Supplement in Response to
Data Adequacy Comments
on the
Application for Certification
for the
Roseville Energy Park
Roseville, California
03-AFC-01

Submitted to the
California Energy Commission

Submitted by
Roseville Electric

December 2003

Figure 1.1-S1a

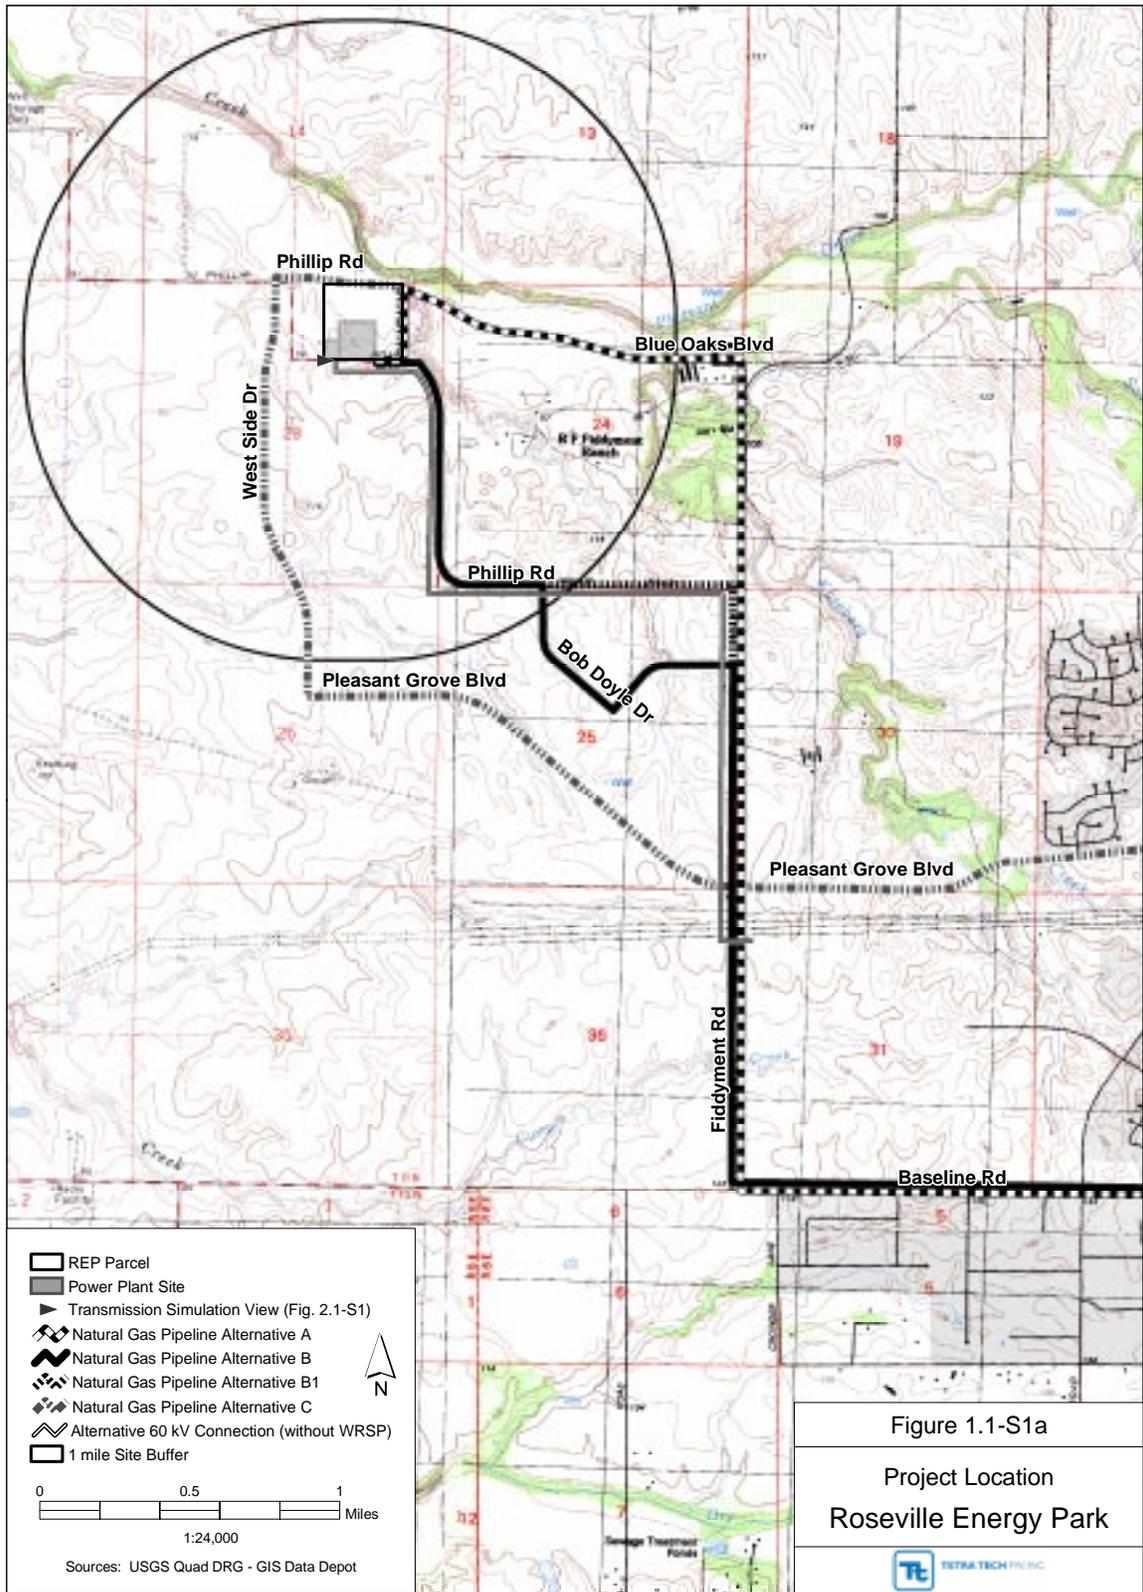
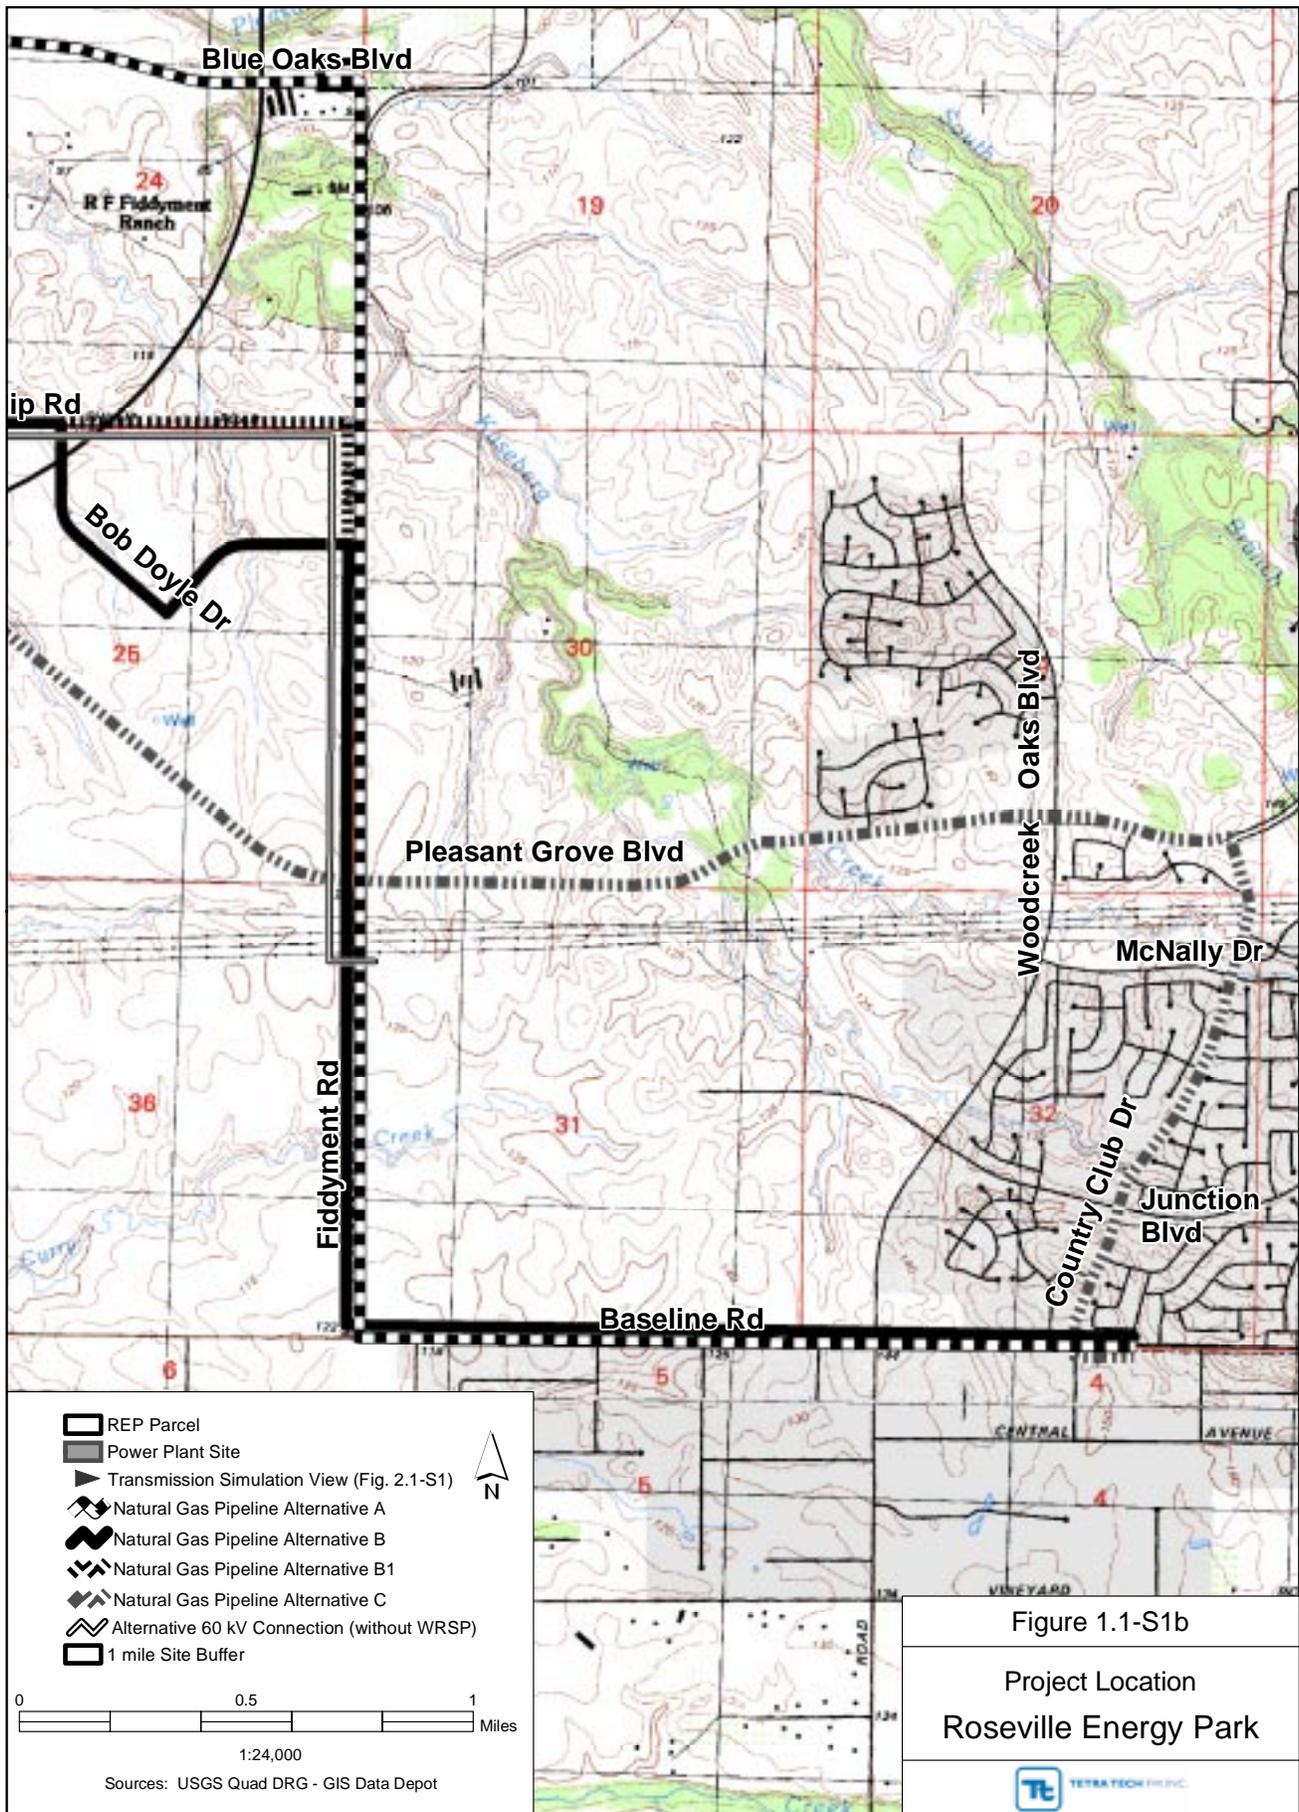
Provide a map depicting the site and its immediate surroundings.

Maps which meet the criteria contained in Appendix B(b)(1)(A) and show the proposed final location and layout of the Power Plant and all related facilities.

Maps which meet the criteria contained in Appendix B(b)(2)(A).

Response—See Figure 1.1-S1 (attached).

Response—See Figure 1.1-S1 (attached).

Response—See Figure 1.1-S1 (attached).
